# 1994 Corvette: Service Bulletin: Garage Shift Delay Engagement (New Garage Shift Package)

**Subject:** Garage Shift Delay Engagement (New Garage Shift Package)

**Bulletin Number:** 47-71-20A

REVISION: 09/12/94

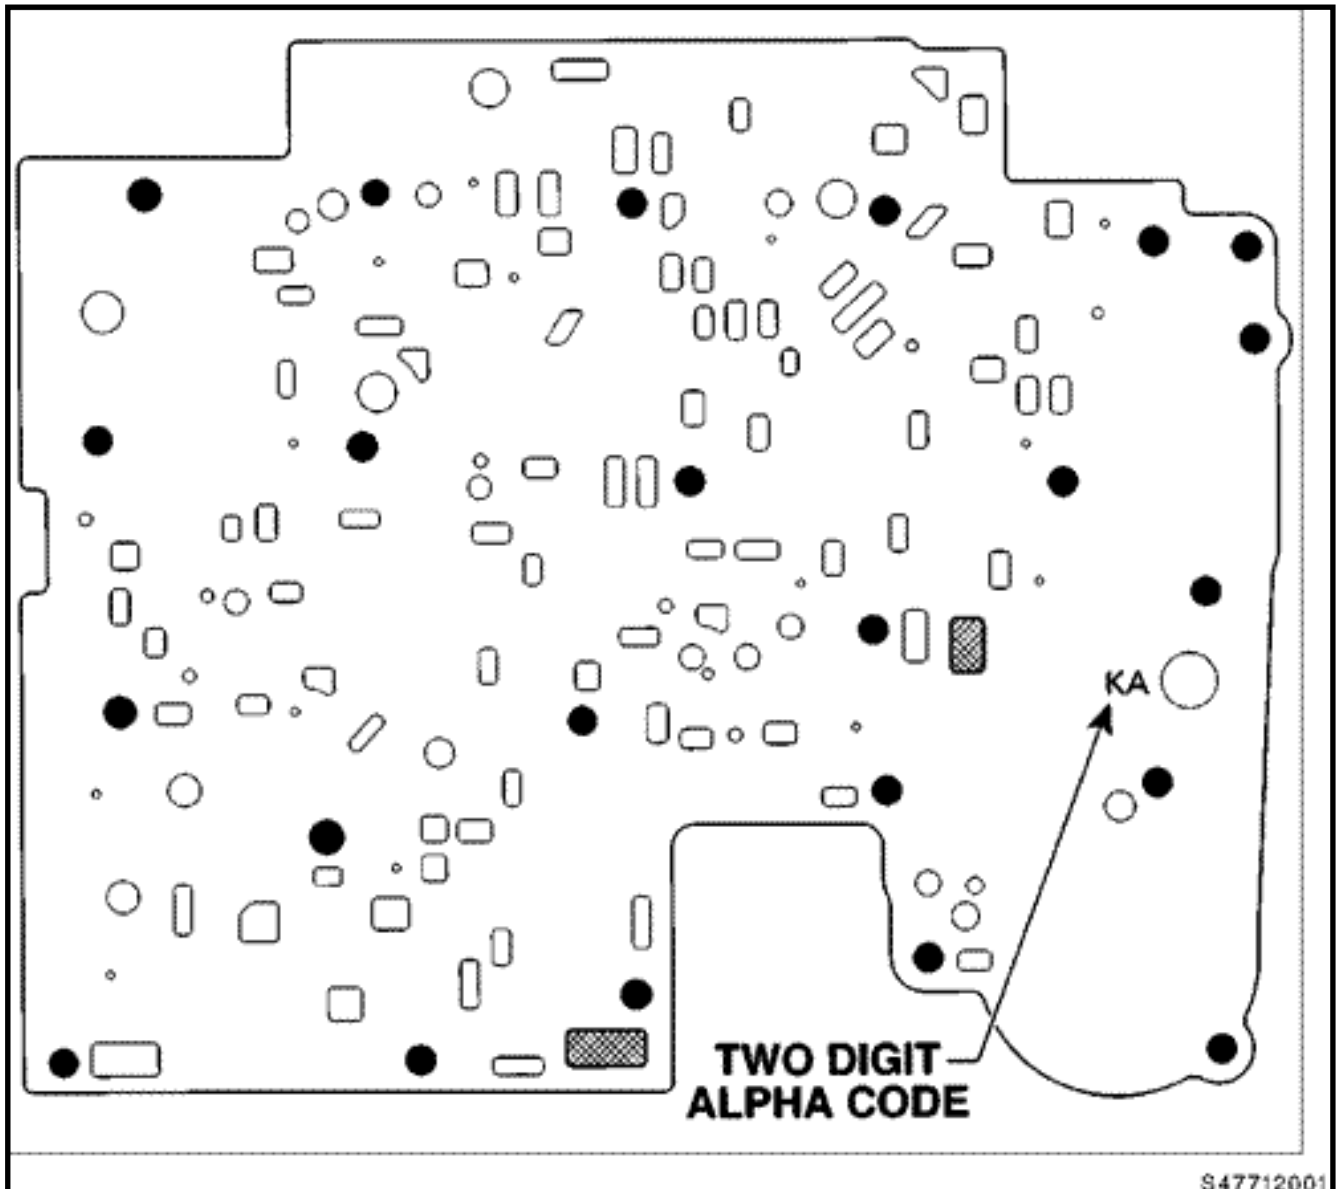
WHEN PERFORMING ANY OTHER REPAIRS ON A 1994 VEHICLE EQUIPPED WITH A HYDRA-MATIC 4L60-E TRANSMISSION BUILT BEFORE MARCH 7, 1994 (JULIAN DATE 066), THE SPACER PLATE IDENTIFICATION MUST BE

CHECKED TO SEE IF THE TRANSMISSION HAS HAD A NEW GARAGE SHIFT PACKAGE INSTALLED TO BE SURE THE TRANSMISSION IS BEING SERVICED WITH THE PROPER PARTS. SEE THE FOLLOWING CHART FOR SPACER PLATE IDENTIFICATION.

THE NEW SPACER PLATES MUST BE USED WITH THE ENHANCED GARAGE SHIFT PACKAGE AND THE ORIGINAL SPACER PLATES MUST BE USED WITH THE ORIGINAL GARAGE SHIFT PACKAGE. THE SPACER PLATES AND GARAGE SHIFT PACKAGES ARE CALIBRATION SENSITIVE; MIXING SPACER PLATES AND GARAGE SHIFT PACKAGES MAY CAUSE PREMATURE FAILURE. WHEN A GARAGE SHIFT PACKAGE IS CHANGED, THE SPACER PLATE MUST ALSO BE CHANGED.
